# BULLETIN

## *PRODUCT SERVICES - Schaumburg*

Subject: MSR2000 and MSF5000 Ferro Resonant power supplies,  
TPN1185A, TPN1218A, TPN1184A, TPN1192A, TPN1226A, TPN1227A

# Product Services Bulletin

Figure 4.

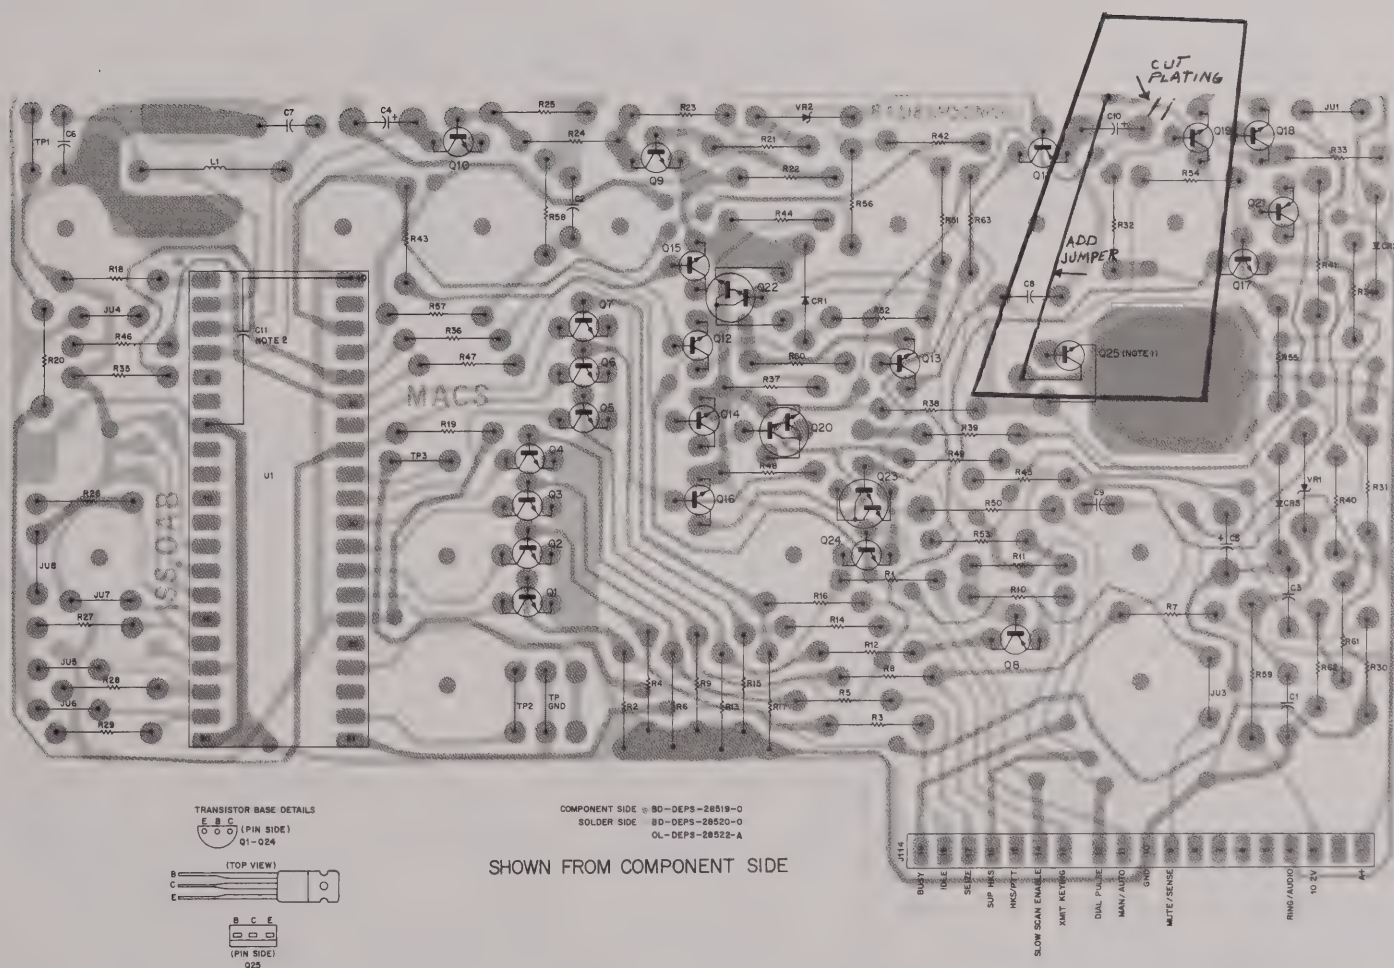
With a low battery voltage (7 volts), the main 10.2 V dc radio regulator and the MACS 5.0 V dc regulator may exist in a quasi-ON state. Voltage to the MACS circuit may drop to 2.0 V dc or less. At a supply voltage of 2.0 V dc the MACS microprocessor may ignore its reset command and activate the ringer line erroneously. The addition of a 12k resistor across the Zener reference diode VR101 in the 10.2 V dc regulator circuit (see Figures 1 and 2) will insure an orderly and predictable shutdown of this regulator under low voltage condition. This modification has been added to all radios shipped after April 6, 1981. In some extreme situations where the vehicle battery voltage drops below 4.0 volts during engine cranking, it may be necessary to reconnect the RESET line as shown in Figures 3 and 4.

Figure 1. Parts Required

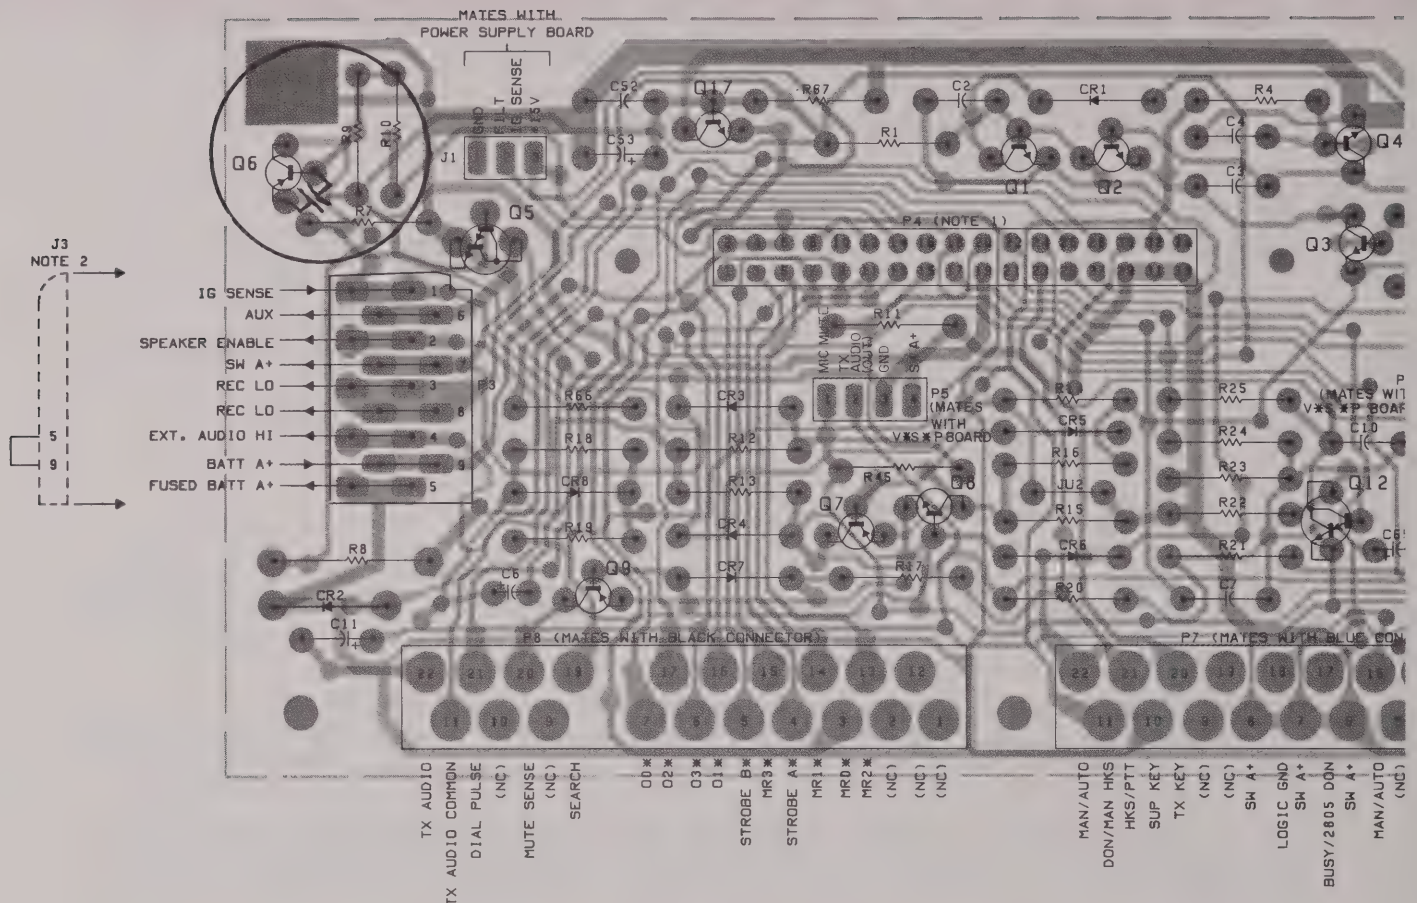
If an auxiliary alarm is to be used with the radiotelephone, the following modification should be made to the TRN4830A Junction box Interconnect Board. See Figure 1.

FIGURE 1

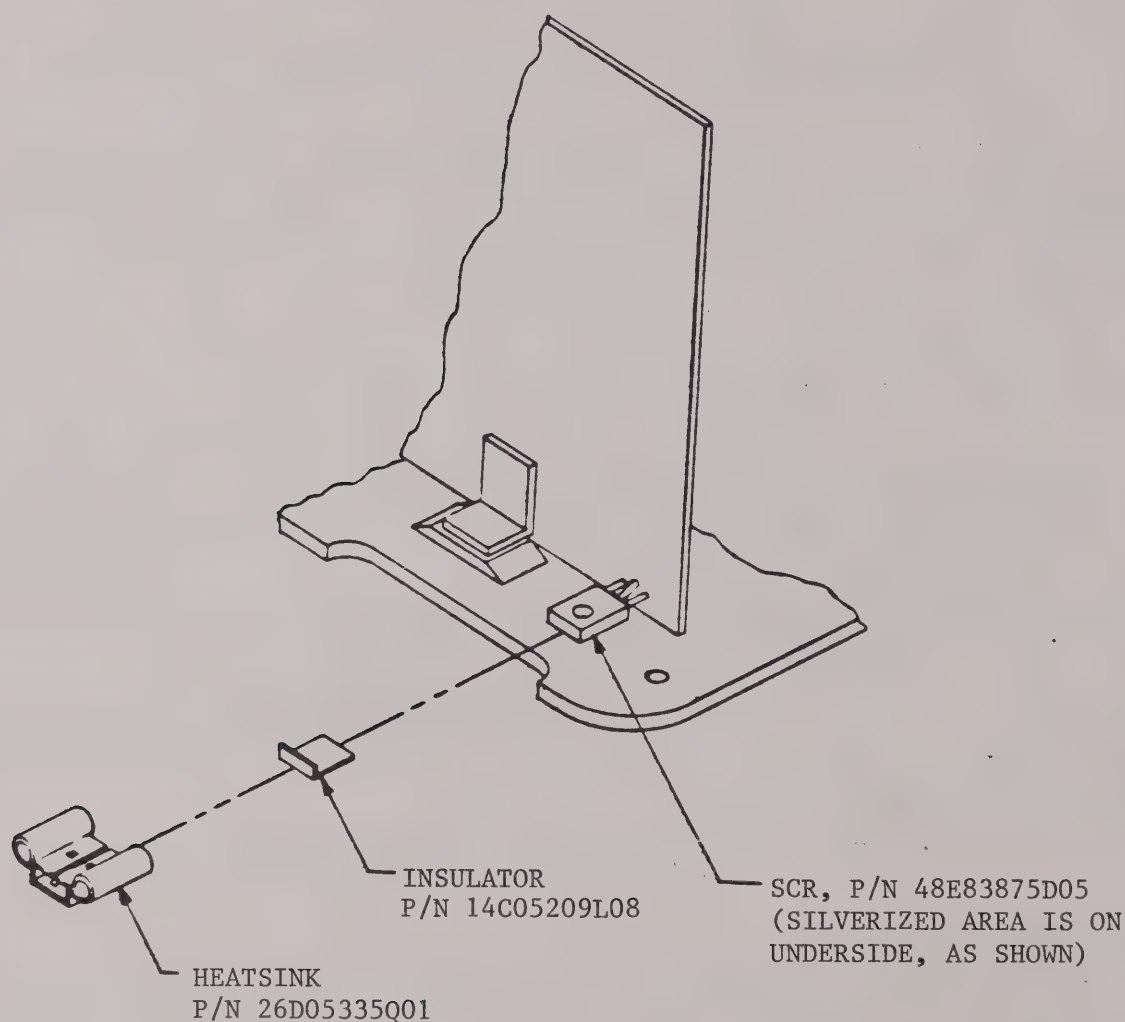
1. Remove cover from multi-unit charger by removing the six (6) perimeter screws in the baseplate.
2. Remove adhesive backing from insulator (P/N 1405209L08) and apply to underside of each of the six (6) SCR's (P/N 4883875D05) making sure to fully cover the silverized area of each SCR (see Figure 1).
3. Slide heatsink (P/N 2605335Q01) onto the SCR as shown in Figure 1, making sure not to bend or break the leads on the SCR or peel off the insulator.

FIGURE 2

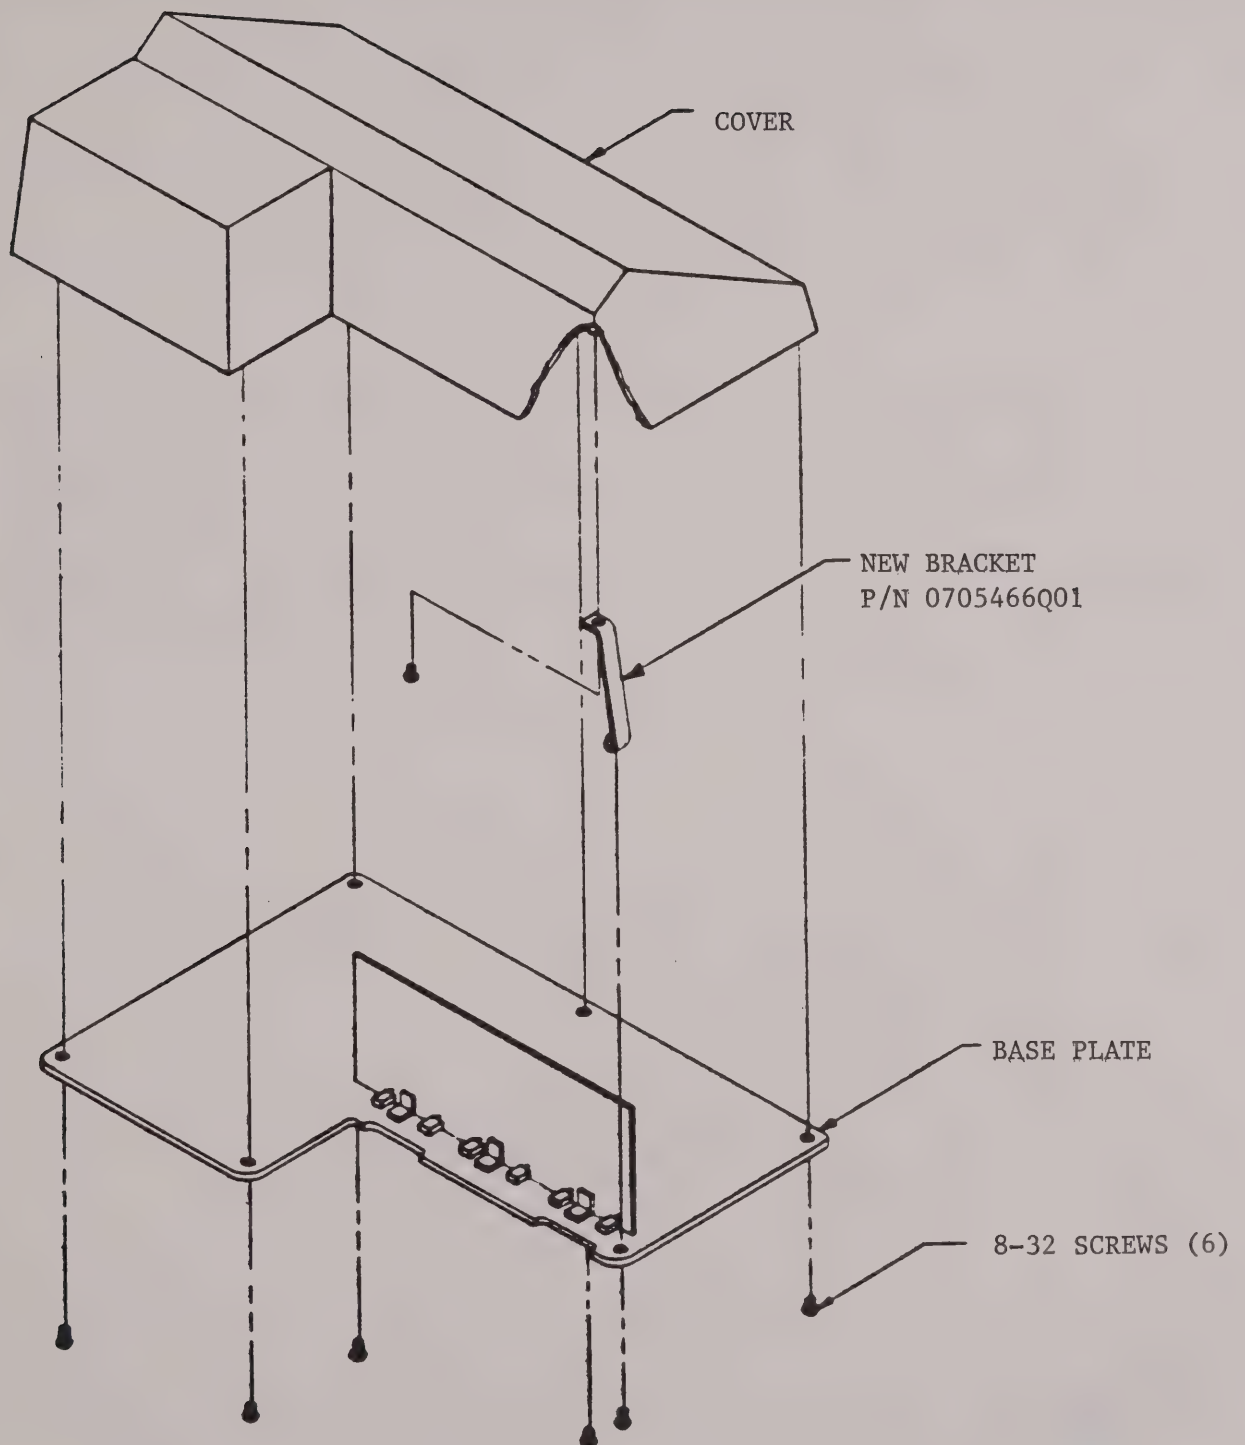
4. Remove housing mounting bracket (P/N 0705880L01) and replace with new bracket (P/N 0705466Q01) oriented as shown in Figure 2.
5. Remove the two resistors R2 and R4 from the circuit board in HT Charger NLN7966 only.
6. Replace cover and test to be sure all six (6) pockets are in good working order.

ADD DIODE  
FIGURE 1

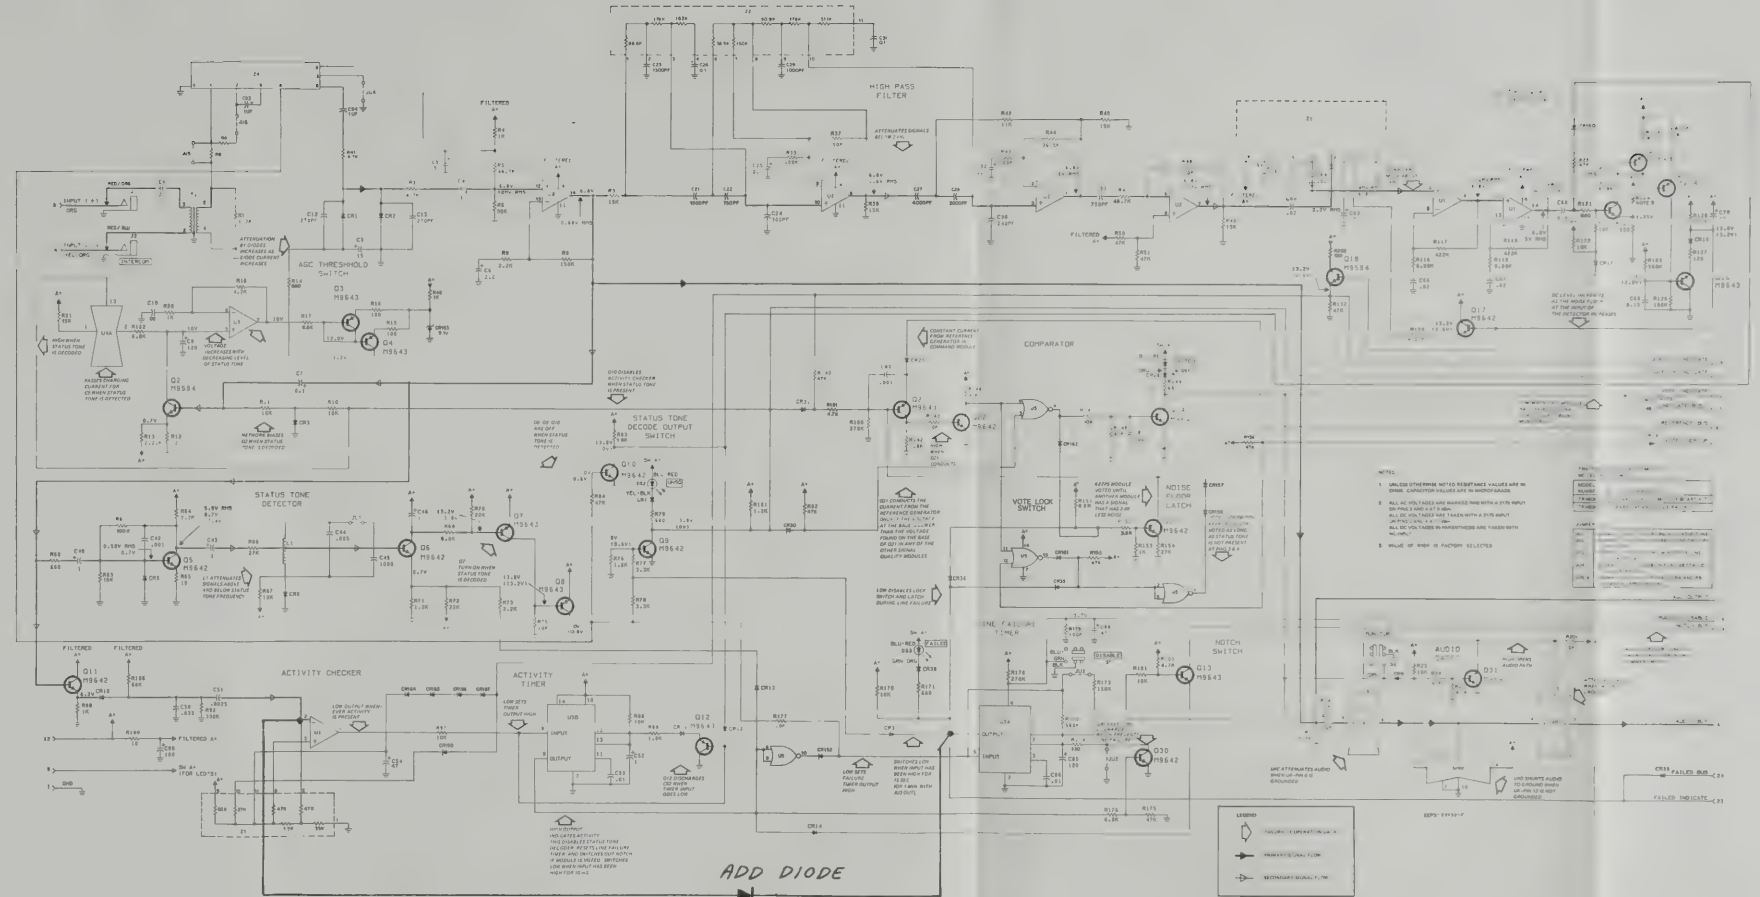
Figures 1 and 2. Modifications to TLN1718B Signal Quality Module
